Groundwater and Wastewater Services File Imaging Project
May 2007
Barcode Font = IDAutomationHC39M

SOIL/SITE EVALUATION
for ON-SITE WASTEWATER SYSTEM

Re: 14155 Monroe Road
File: 2732B
Parcel: 215-051-25

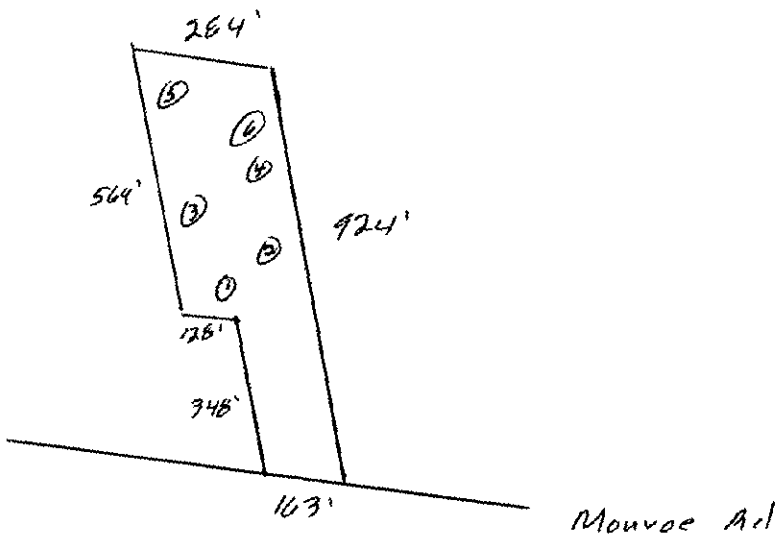
OTHER FACTORS (.1946): _____
SITE CLASSIFICATION (.1948): Unsuitable
EVALUATED BY: M. A. Maulis 2-16-99
OTHER(S) PRESENT: LSS

COMMENTS Not sure if MTE Report yet

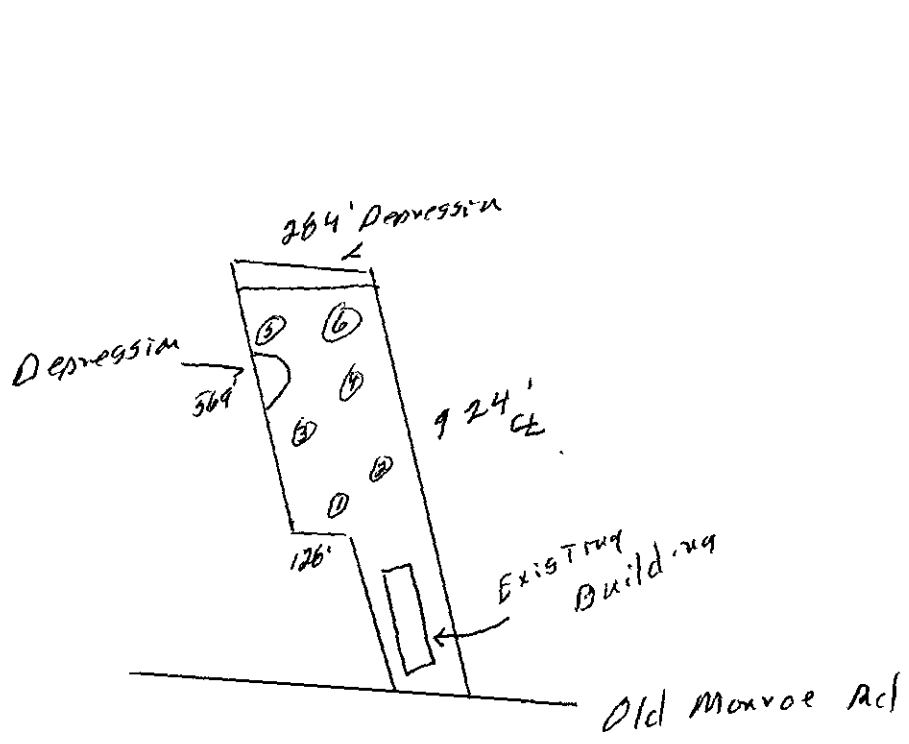
OTHER FACTORS (.1946):
SITE CLASSIFICATION (.1948): Unsuitable
EVALUATED BY: W. R. Mallis 1-6-99
OTHER(S) PRESENT: LSS

COMMENTS Possible 100% depression
